Hartley Nature Center

Accessibility Review

Transition Plan - (location/priority)

Photo 1: View of typical classroom. Sound systems are provided. Acquire an assistive listening system.

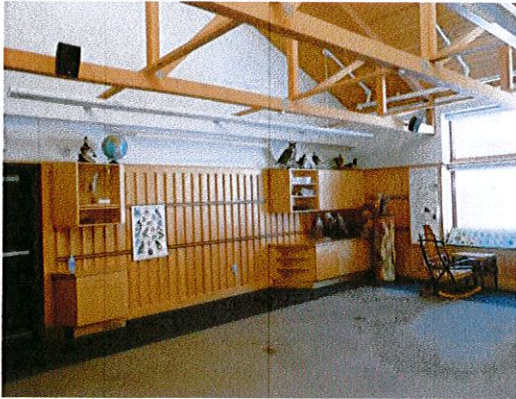
Location	Solution / Comments	Qty	Unit Cost	Total Cost	Priority	Estimated Compl. Date	Person Responsible	Actual Compl. Date	Actual Cost
JQP # / Item #									
Classroom 1									
26B 15669	Provide a portable assistive listening system with signage. IBC 1108.2.6 <i>Photo 1.</i>	1	\$1,200	\$1,200	2				
Classroom 3									
26B 15679	Provide a portable assistive listening system with signage. IBC 1108.2.6 <i>Cost already calculated.</i>	1	\$0	\$0	2				
Parking									
05H 15680	Stripe to provide an accessible parking stall that is 8' wide with an adjacent 8' access aisle. It is preferred that the access aisle be located on the passenger side of the vehicle. MN 1341 502.4.2 <i>Re-stripe the accessible parking spaces. There are currently 2 signs designating accessible parking spaces, but the striping on the surface has faded.</i>	1	\$150	\$150	2				
				Priority # 2 Total	\$1,350

Photo 4: Add pull style hardware to both sides of the accessible stall door.

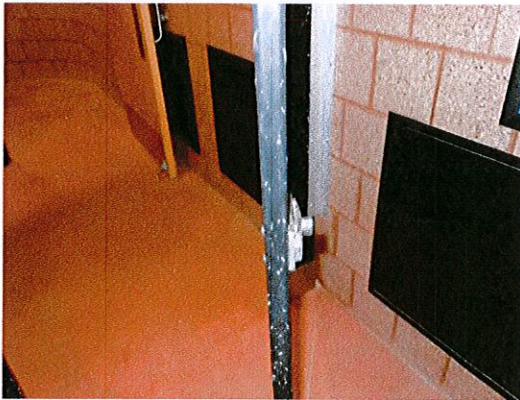
Location JQP # / Item #	Solution / Comments	Qty	Unit Cost	Total Cost	Priority	Estimated Compl. Date	Person Responsible	Actual Compl. Date	Actual Cost
Classroom 1									
40B1 15668	Relocate compliant sign to the wall adjacent to latch side of door, 48" minimum to the baseline of the lowest Braille characters and 60" maximum to the baseline of the highest tactile character. ICC/ANSI 703.3.10, 703.4.5	1	\$30	\$30	3				
Drinking Fountain									
41A1 15675	Provide a minimum of one drinking fountain that has a 36" spout height accessible for persons using wheelchairs (low) and one standard height (high) drinking fountain with a spout height 38" minimum and 43" maximum for persons who have difficulty bending or stooping. ANSI 602.4 <i>Currently provides 1 drinking fountain with 36" spout height.</i>	1	\$1,500	\$1,500	3				
Men's Toilet Room									
22H1 15676	Provide staple style pulls on both sides of the accessible stall door near the latch. ANSI 604.8.3 <i>Photo 4.</i>	2	\$50	\$100	3

22Z 15677	Provide a coat hook positioned so the highest operable part is no higher than 48". ICC / ANSI 604.11.	1	\$50	\$50	3				
				<i>Location Subtotal:</i>					\$150
Women's Toilet Room									
22H1 15670	Provide staple style pulls on both sides of the accessible stall door near the latch. ANSI 604.8.3 <i>Photo 4.</i>	2	\$50	\$100	3				
22Z 15671	Provide a coat hook positioned so the highest operable part is no higher than 48". ICC / ANSI 604.11	1	\$50	\$50	3				
				<i>Location Subtotal:</i>					\$150
				Priority # 3 Total					\$1,830

Photo 5: The women's toilet room does not currently provide maneuvering clearance on the pull side of the door. (The door is propped in the 'open' position.)

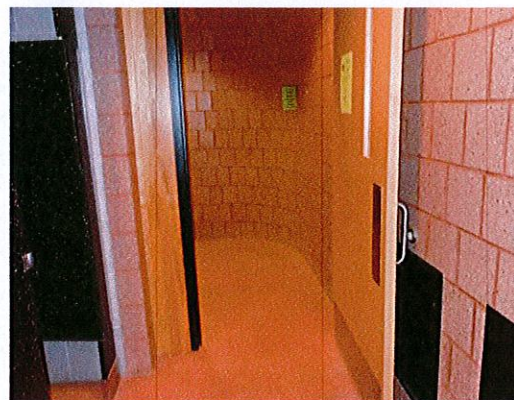
Location JQP # / Item #	Solution / Comments	Qty	Unit Cost	Total Cost	Priority	Estimated Compl. Date	Person Responsible	Actual Compl. Date	Actual Cost
Men's Toilet Room									
20P 15678	Lower the window in the door (or the sidelite) so the bottom is at 43" maximum. ICC / ANSI 404.2.10 <i>Currently at 48".</i>	1	\$250	\$250	4				
Washroom									
22V 15674	Install a full-height mirror or provide a mirror where the bottom of the reflective surface is no higher than 40" above the floor. MN 1341 603.3 <i>Currently at 41".</i>	1	\$300	\$300	4				
Women's Toilet Room									
20P 15673	Lower the window in the door (or the sidelite) so the bottom is at 43" maximum. ICC / ANSI 404.2.10 <i>Currently at 48". The door was propped 'open' at the time of site visit.</i>	1	\$250	\$250	4				
22-20B 15672	Re-hinge / relocate door to provide needed maneuvering clearance on the latch pull side of the door. ICC / ANSI 404.2.3, Table 404.2.3.1 <i>Currently provides 10 1/2" on the pull side of the door. The door was propped 'open' at the time of site visit. Photo 5.</i>	1	\$750	\$750	4
